DRAINAGE INFORMATION SHEET

PROJECT TITLE: RUTLEDGE LOT 1023 ZONE ATLAS/DRNG. FILE #: D-23001F
DRB #: _____ EPC #: _____ WORK ORDER #: _____
LEGAL DESCRIPTION: LOT 1023, UNIT 10, SANDIA HEIGHTS SOUTH
CITY ADDRESS: 1023 TRAMWAY LANE NE
ENGINEERING FIRM: MCDOWELL ENGINEERING, INC. CONTACT: JACKIE MCDOWELL
ADDRESS: 7820 BEVERLY HILLS NE PHONE: 828-2430
OWNER: ROSEMARY RUTLEDGE CONTACT: ROSEMARY RUTLEDGE
ADDRESS: 6128 PADRE CT. NE PHONE: 828-9644
ARCHITECT: _____ CONTACT: _____
ADDRESS: _____ PHONE: _____
SURVEYOR: _____ CONTACT: _____
ADDRESS: _____ PHONE: _____
CONTRACTOR: _____ CONTACT: _____
ADDRESS: _____ PHONE: _____

RE: Grading and Drainage Plan for Lot 1023, Sandia Heights South, (D23/D1F) (PWDN-990124) Engineer's Stamp Dated 6/9/99.

BERNALILLO COUNTY			NEW MEXICO	
LOT 1023, UNIT 10 SANDIA HEIGHTS SOUTH				
RUTLEDGE/NEUMANN GRADING & DRAINAGE PLAN				
McDowell Engineering Inc.				
Designed JSM		Drawn STAFF		Checked JSM
File RUTO199L		Date JUNE, 1999		Sheet 1 of 1

MAP NUMBER
35001C0161 E

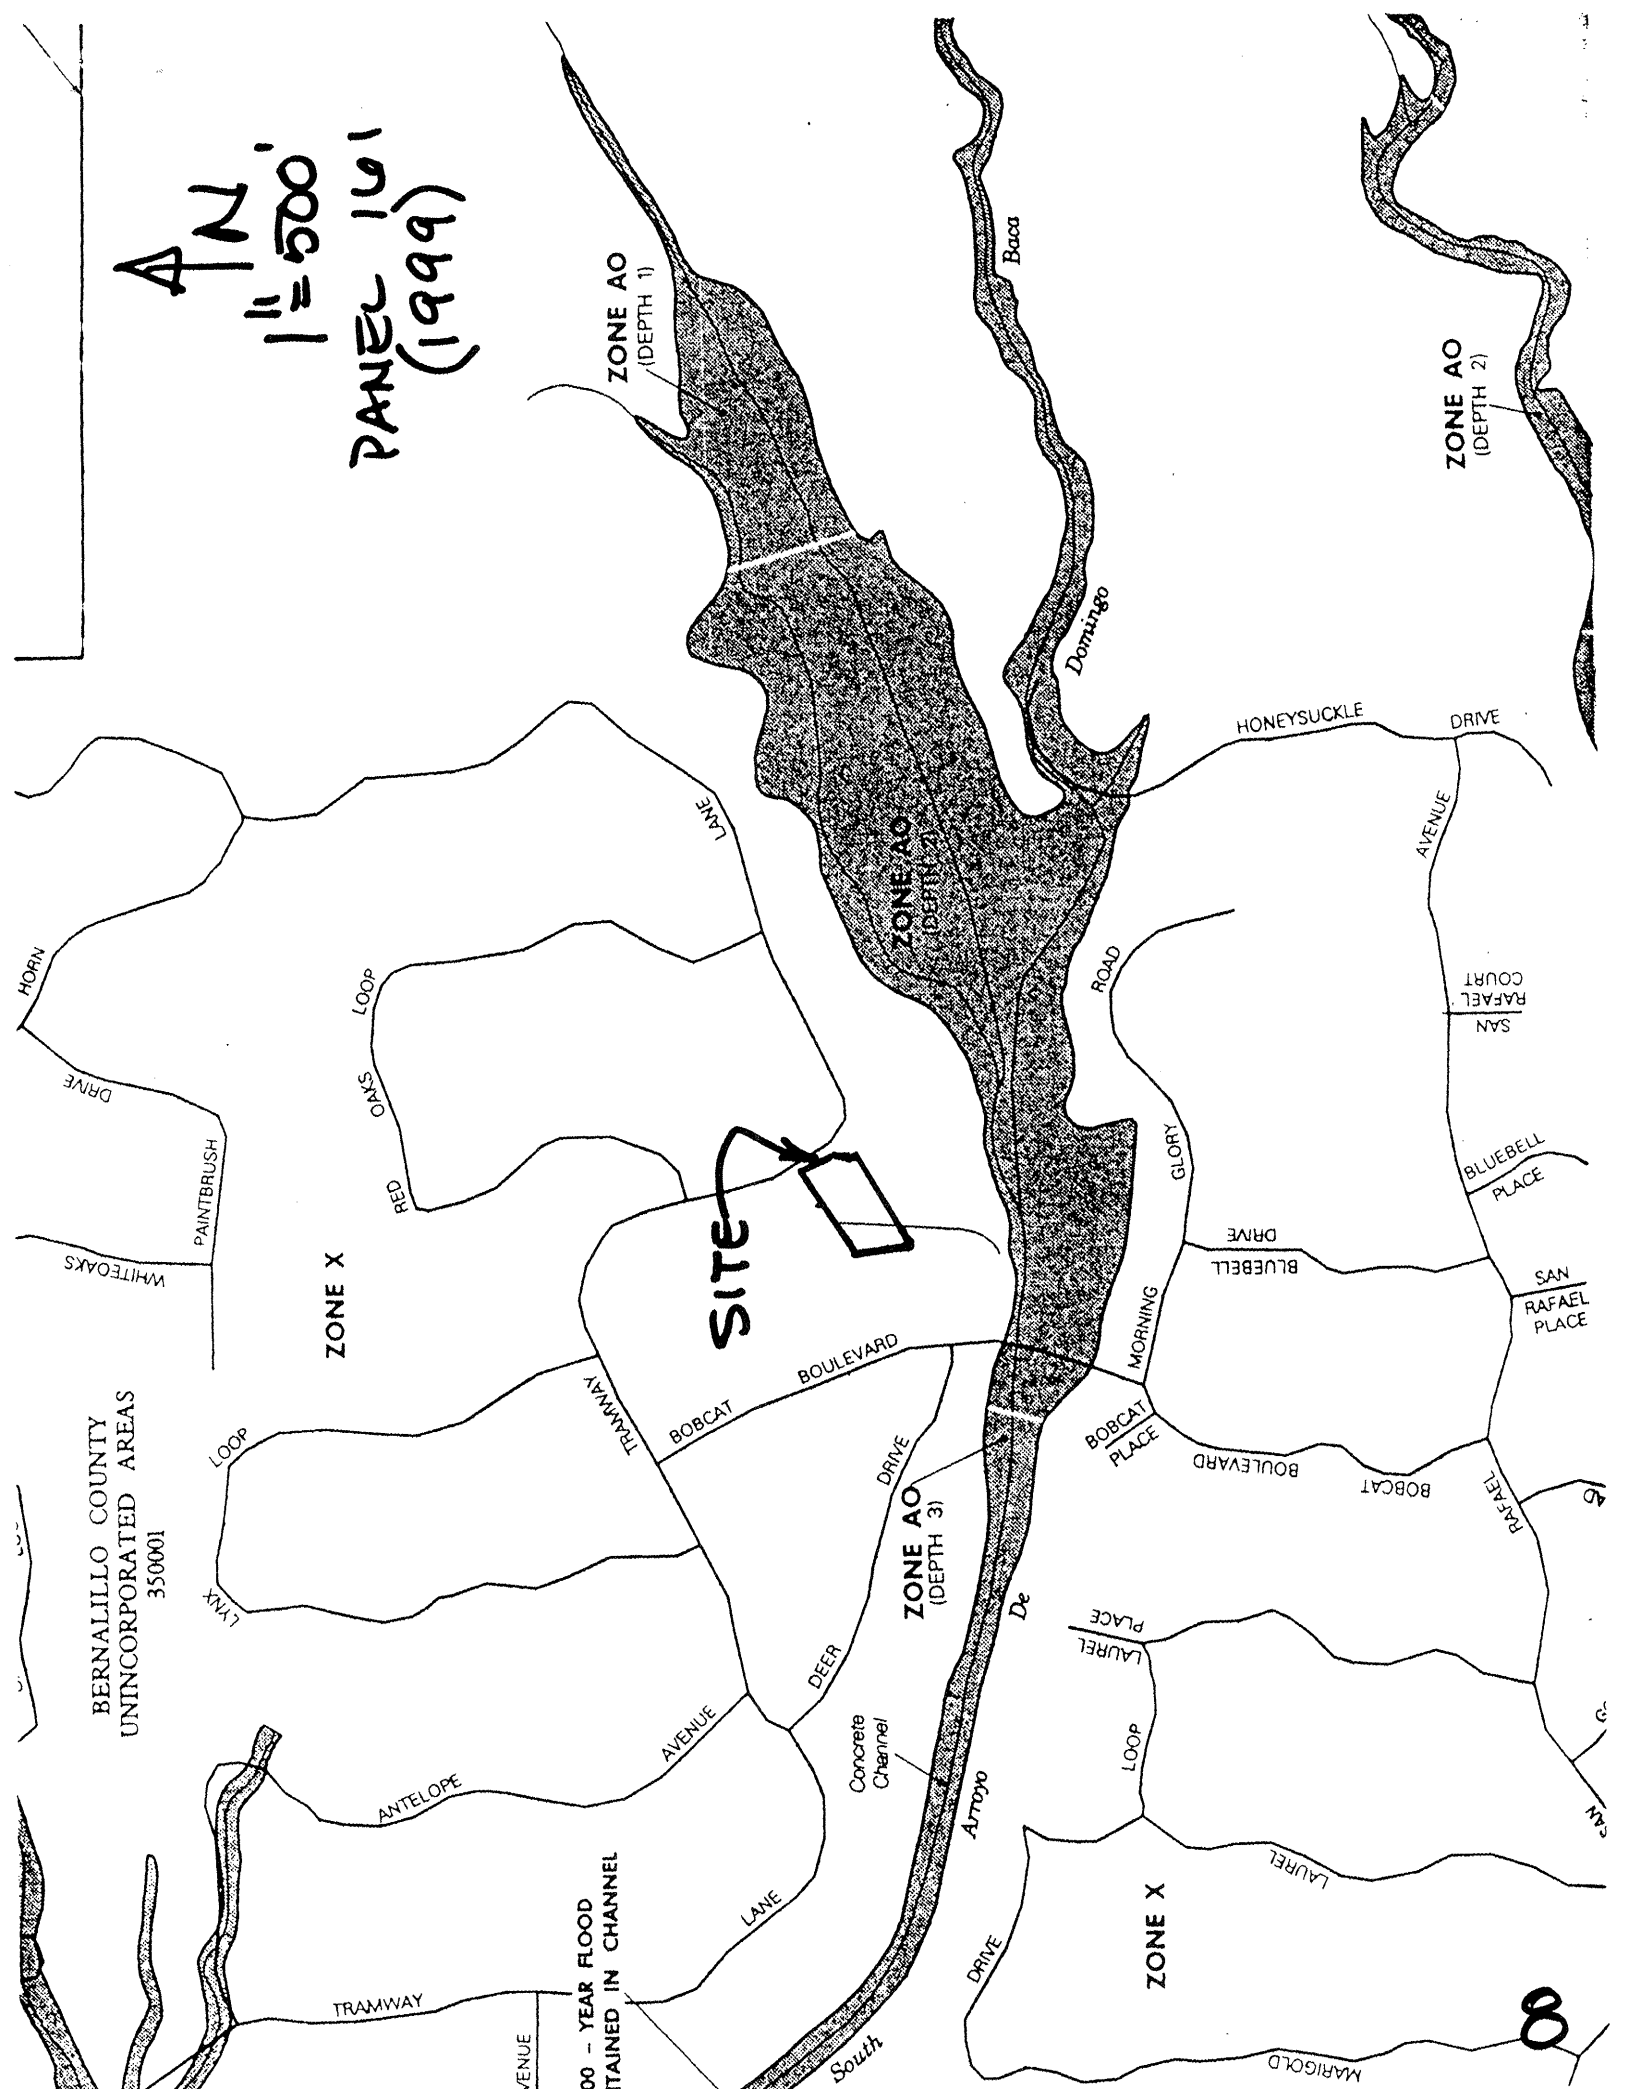
For your information, the March 31, 1999 preliminary flood maps referenced on the plan will not be adopted by the Community at this time. We have prepared comments and will request that FEMA reissue the preliminary maps. If FEMA agrees, it appears that new flood maps will not be adopted for at least eight months.

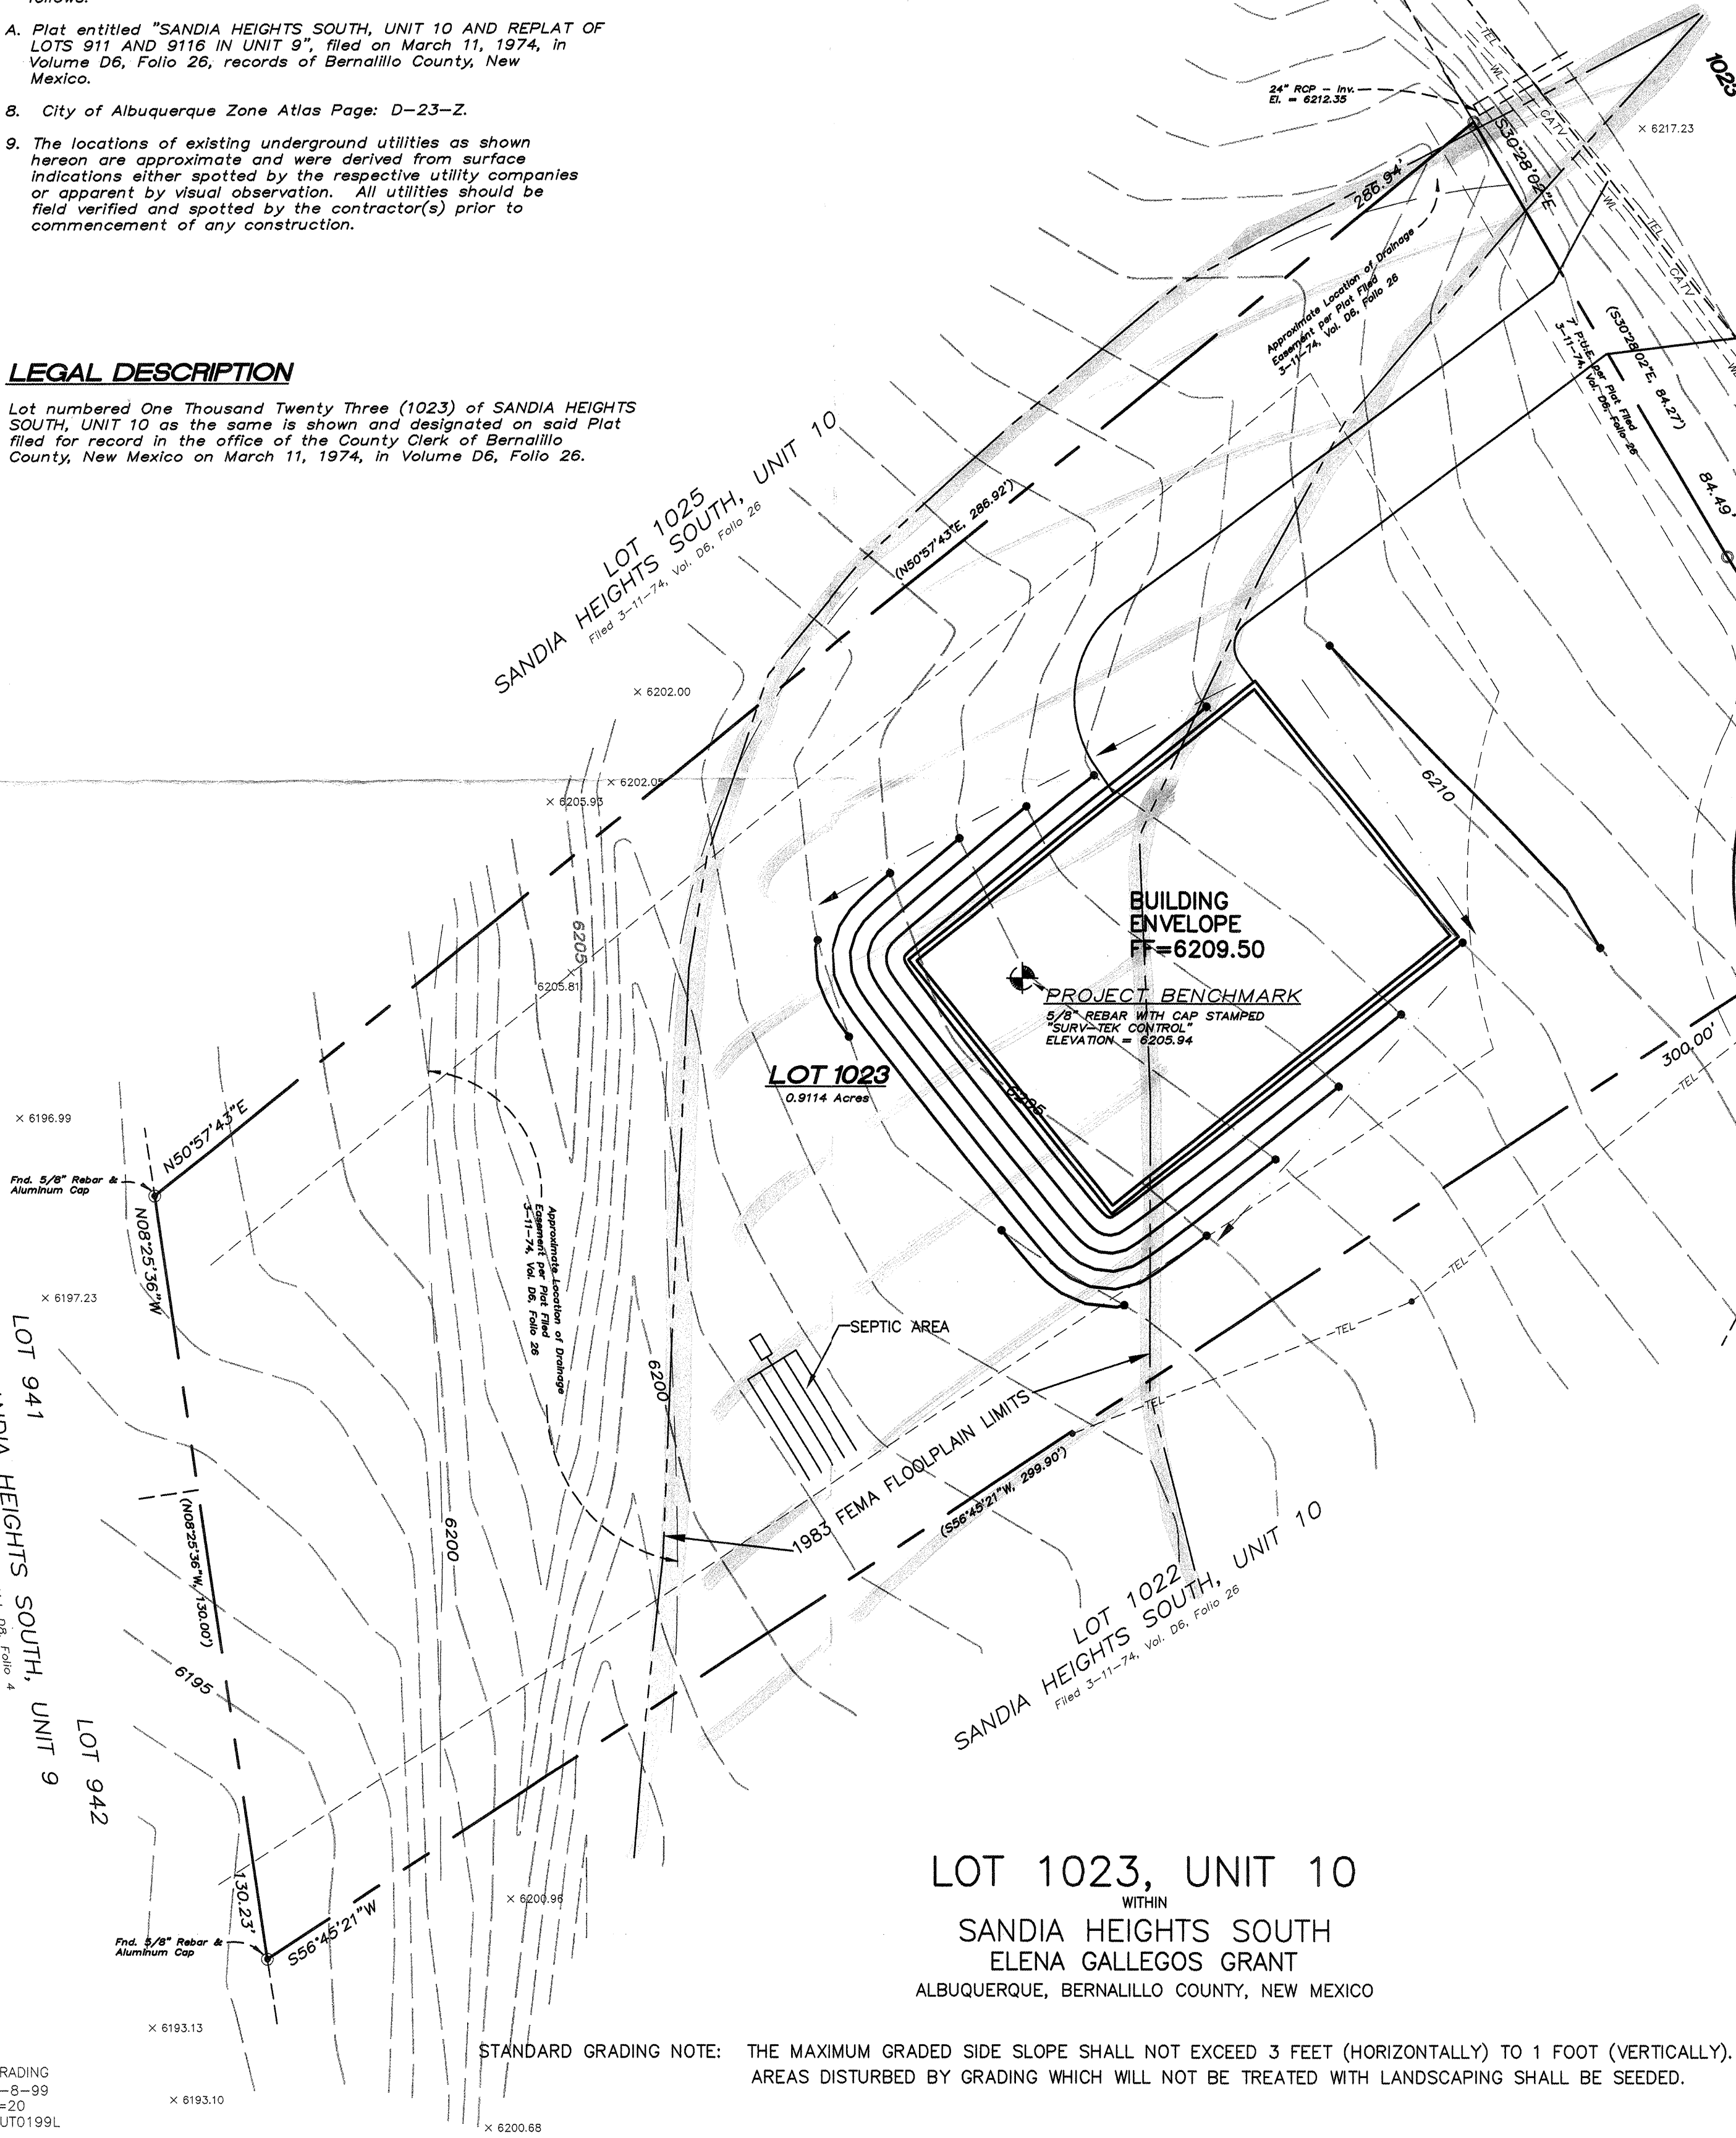
1. The center portion of this Lot that is in the existing FEMA floodplain must be within an AMAFCA easement. No structures will be allowed within this easement without AMAFCA Board approval. Therefore, it is recommended that the residence be moved outside of the AMAFCA easement, or wait until the new FEMA maps are adopted for the floodplain to be removed.
2. Please use the more recent mapping for the off-site drainage basin map.
